Re: State Decision Document and Technical Analysis, New Lease,
Genwal Coal Company, Inc. Crandall Canyon Mine, ACT/015/032,
Folder #2, Emery County, Utah

UTAH DIVISION OF OIL, GAS & MINING
STATE DECISION DOCUMENT AND
TECHNICAL ANALYSIS

Genwal Coal Company, Inc.
Crandall Canyon Mine
New Lease
ACT/015/032
Emery County, Utah

Figure 5

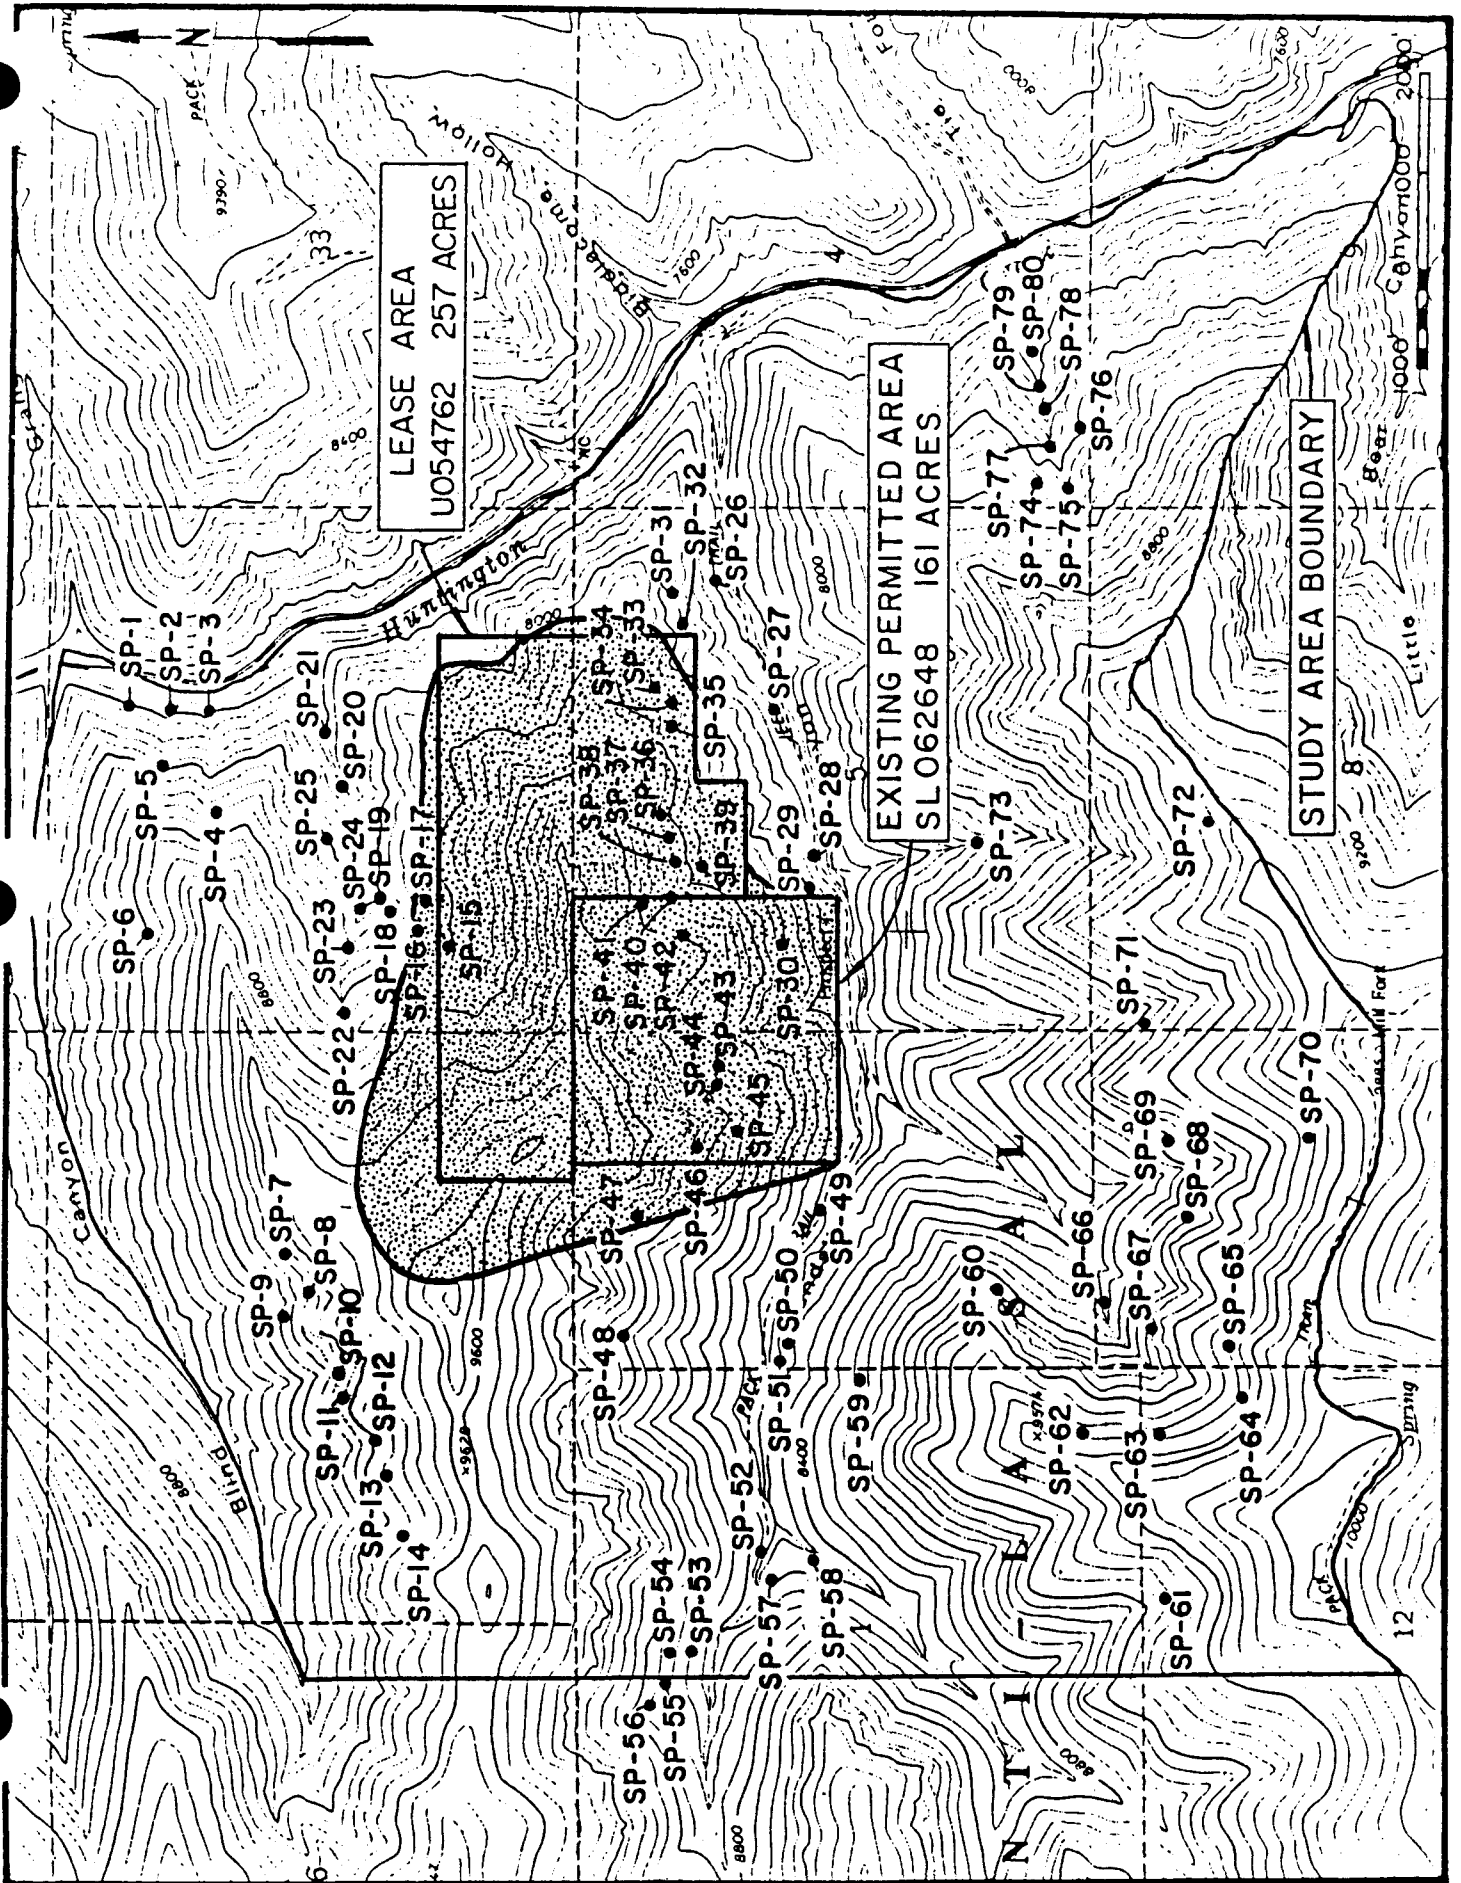
Subsidence impacts are largely related to extension and expansion of the existing fracture system and upward propagation of new fractures. Potential area of impacts is shown on Figure 5. Inasmuch as vertical and lateral migration of water appears to be largely controlled by fracture conduits, readjustment or realignment in the conduit system may potentially produce changes in the configuration of ground-water flow. Potential changes include increased flow rates along fractures that have "opened" and diverting flow along new fractures or permeable lithologies. Subsurface flow diversions may cause the depletion of water in certain localized aquifers, whereas increased flow rates along fractures would reduce ground-water residence time and potentially improve water quality.
